OF
FREEMAN LOGISTICS

| 5 | 12/13/24 | DTC | JSM | JSM | SEPA RESUBMITTAL |

EXISTING CONDITIONS
FOR
FREEMAN LOGISTICS

Job Number
21585
Sheet
C8 of **44**

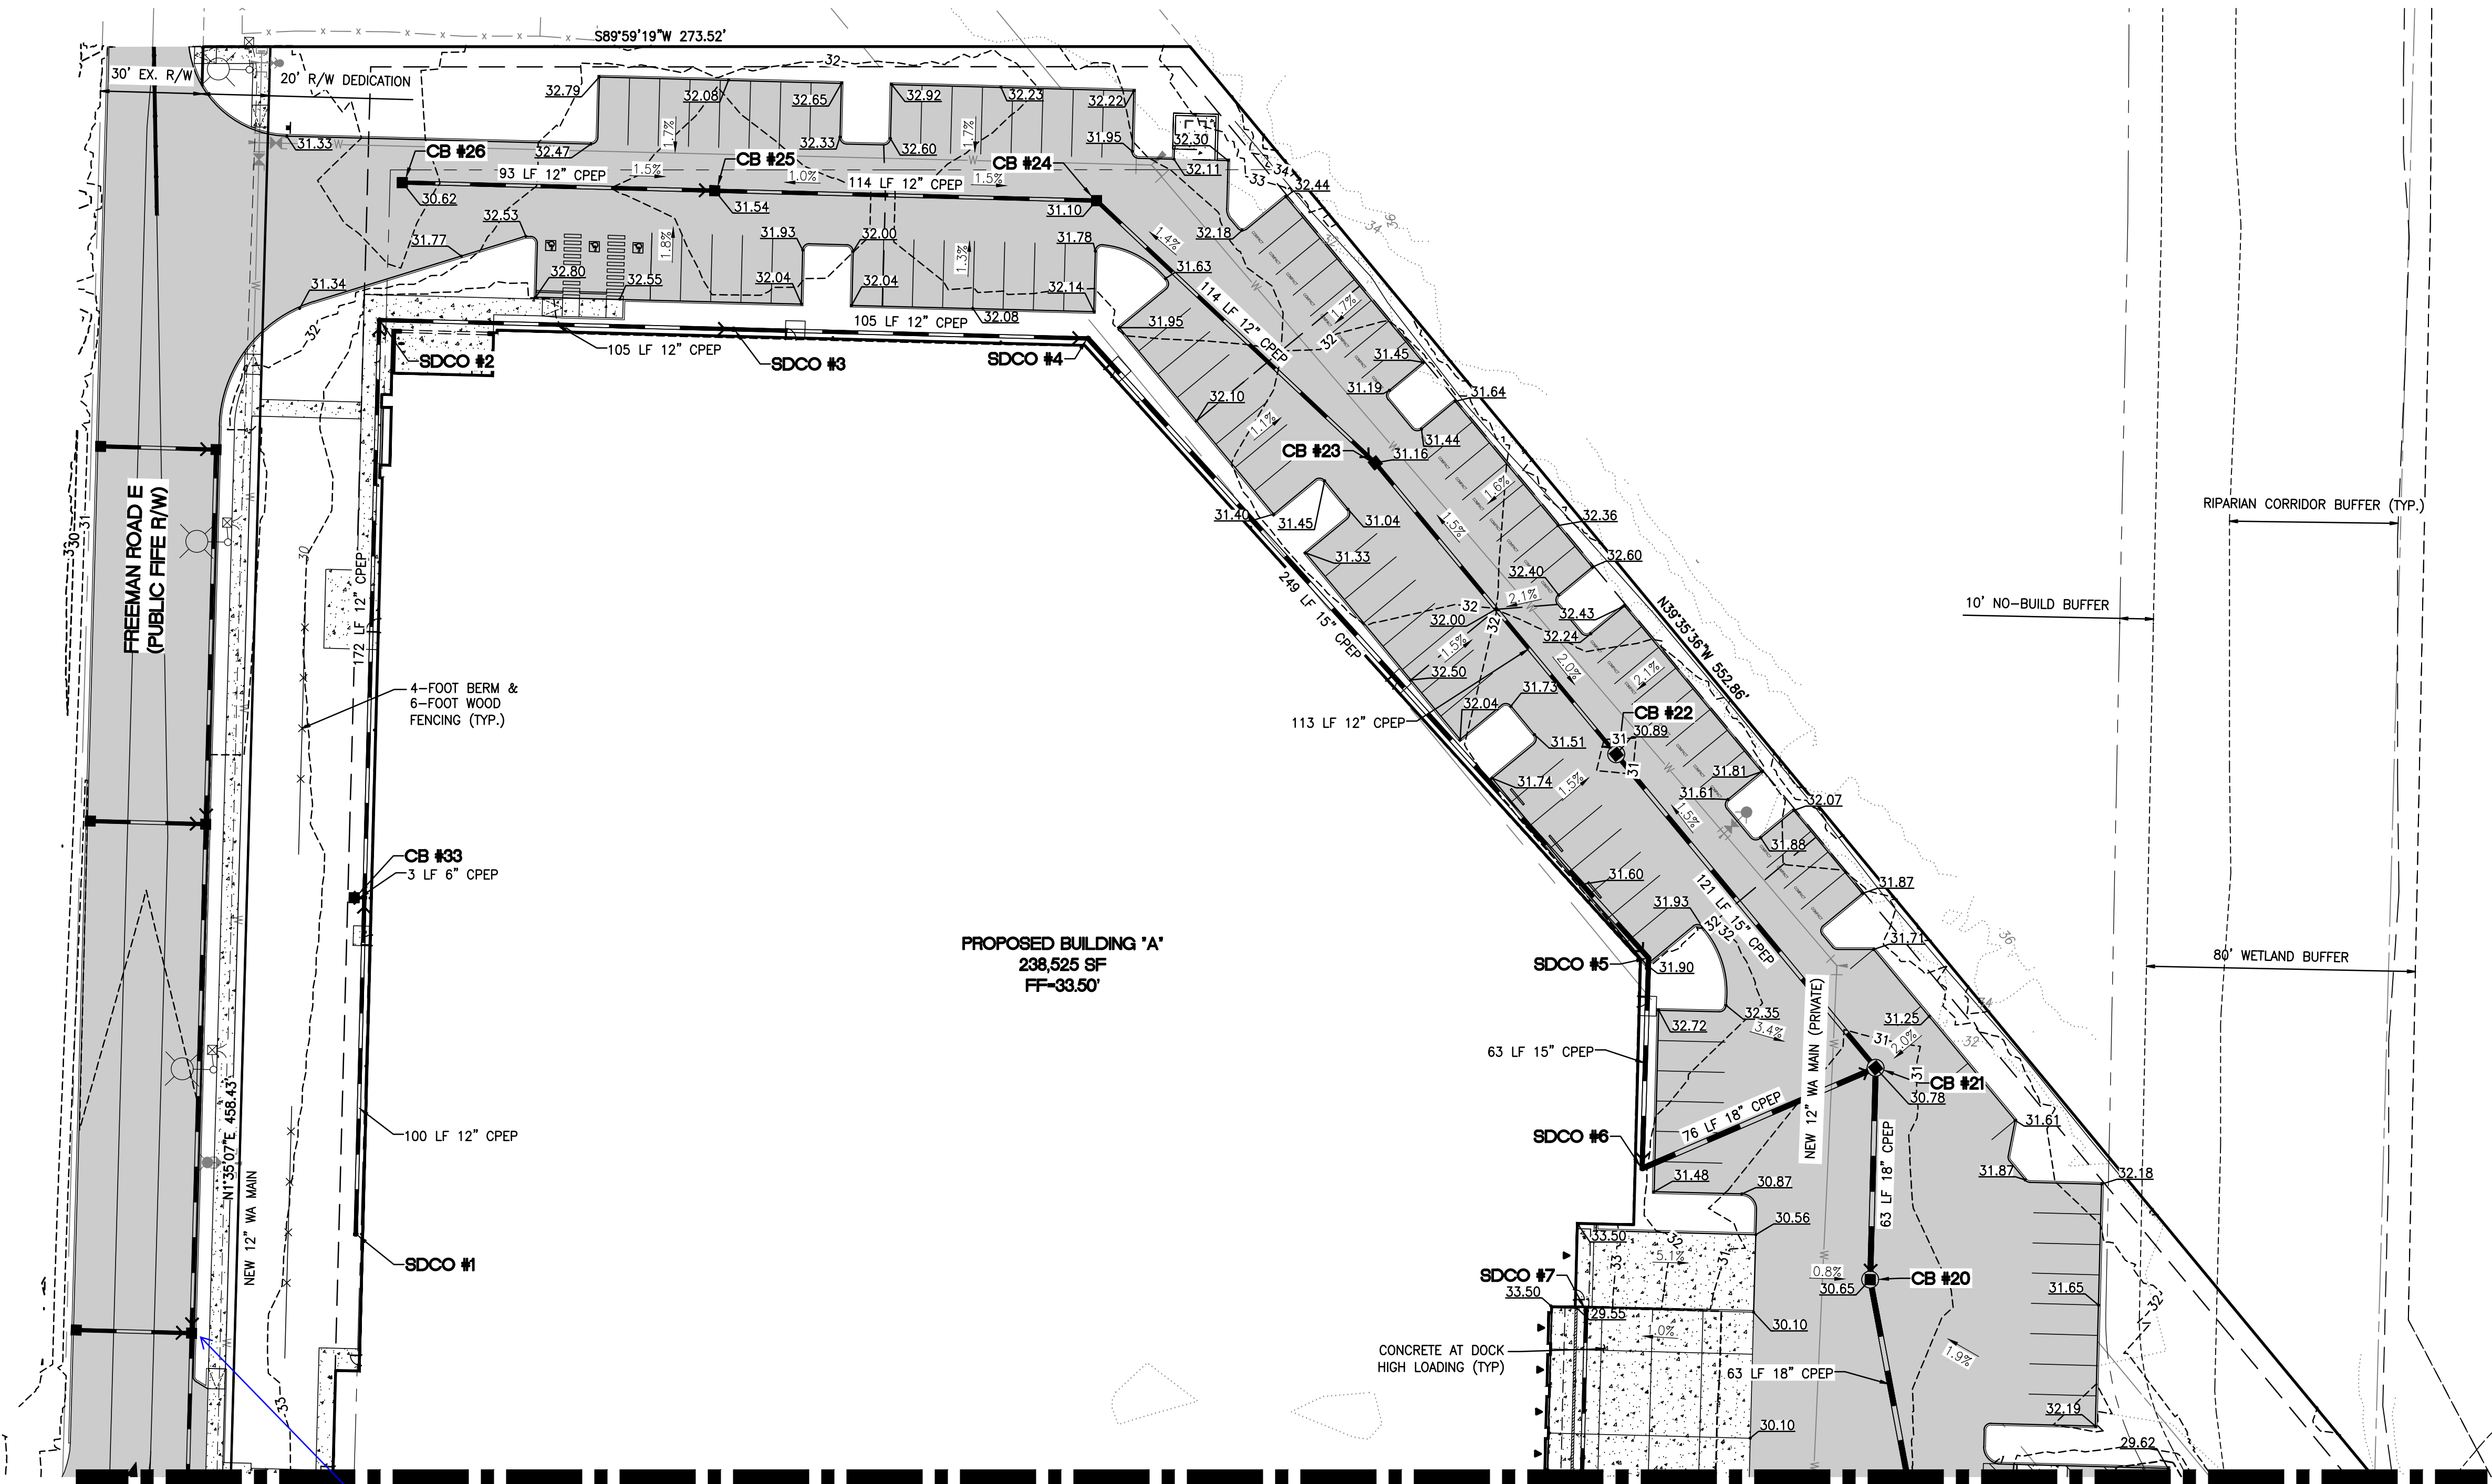
FIFE COMMENT: Gravity storm facilities within the City of Fife will be owned and maintained by CoF and constructed per CoF approvals and standards. Drainage permits will be required for design review.
[CIVIL-SEPA-2024 RESUB, Sheet C8]

Sheet
C19 of **44**

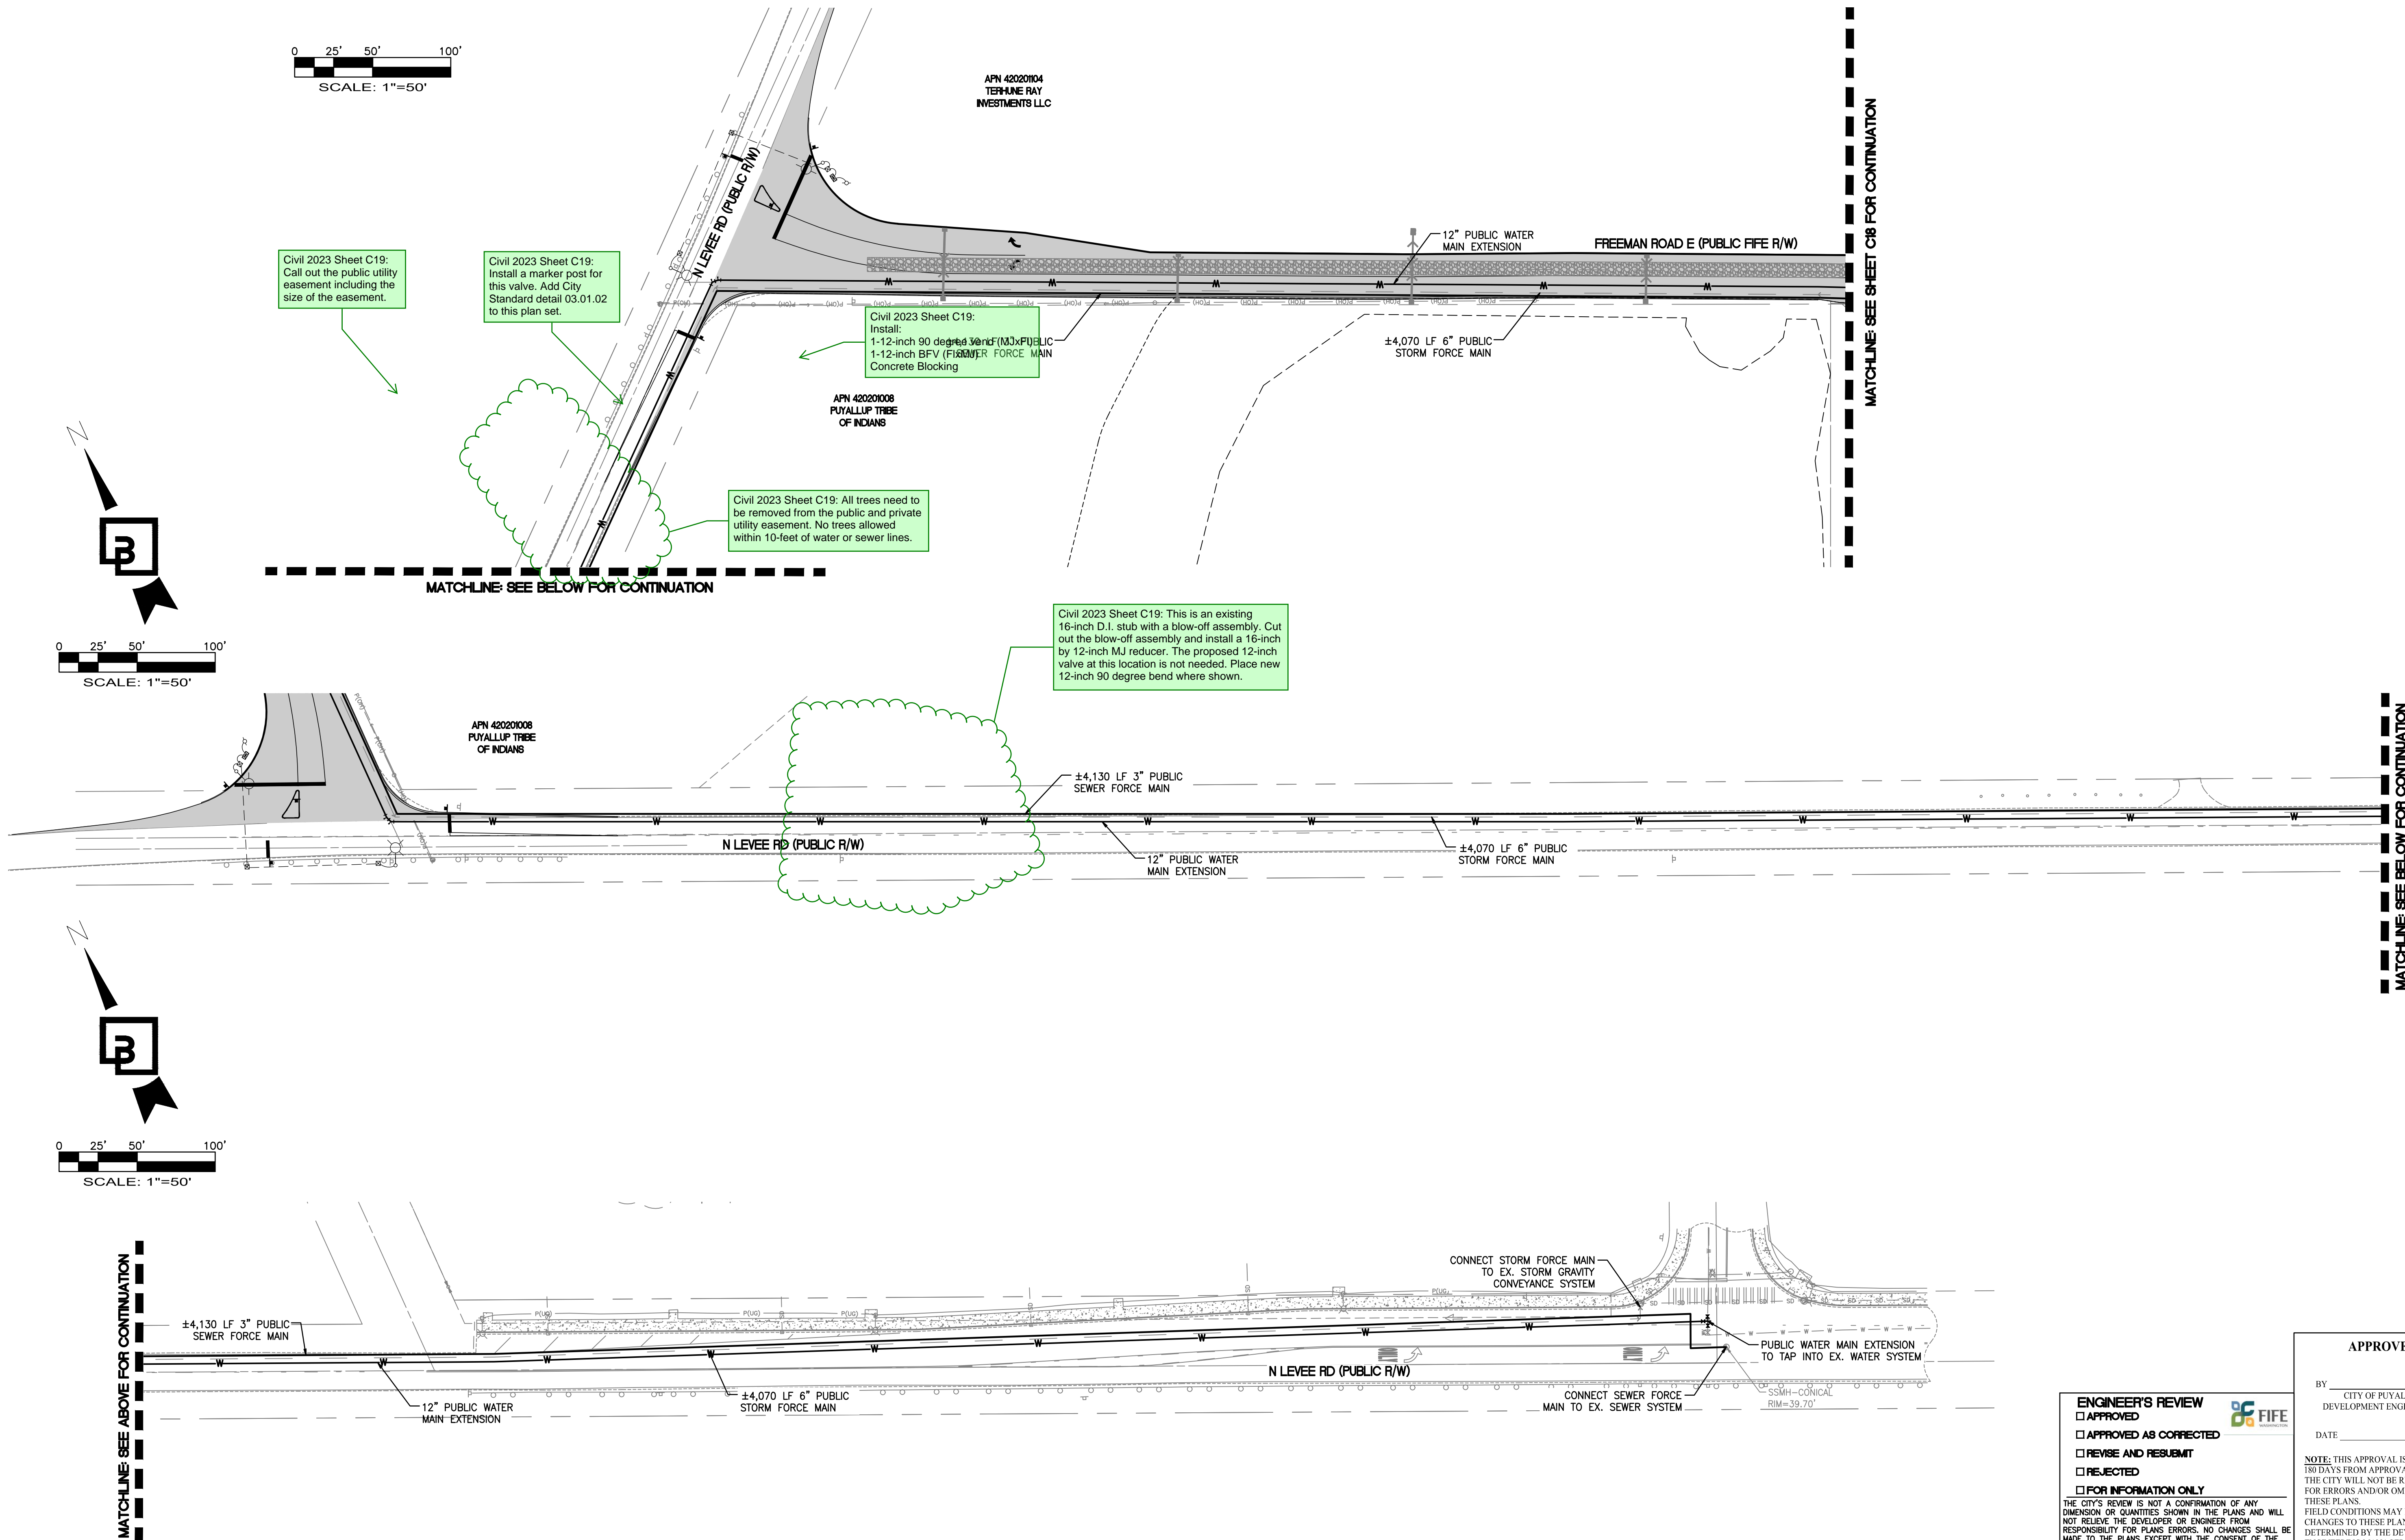
Civil 2023 Sheet C19:
Call out the public utility
easement including the
size of the easement.

Civil 2023 Sheet C19:
Install a marker post for
this valve. Add City
Standard detail 03.01.02
to this plan set.

Civil 2023 Sheet C19:
Install:
1-12-inch 90 degree bend (NJ) x PUBLIC
1-12-inch B.V. (F160) x R. FORCE MAIN
Concrete Blocking

Civil 2023 Sheet C19: All trees need to
be removed from the public and private
utility easement. No trees allowed
within 10-feet of water or sewer lines.

Civil 2023 Sheet C19: This is an existing
16-inch D.I. stub with a blow-off assembly. Cut
out the blow-off assembly and install a 16-inch
by 12-inch MJ reducer. The proposed 12-inch
valve at this location is not needed. Place new
12-inch 90 degree bend where shown.
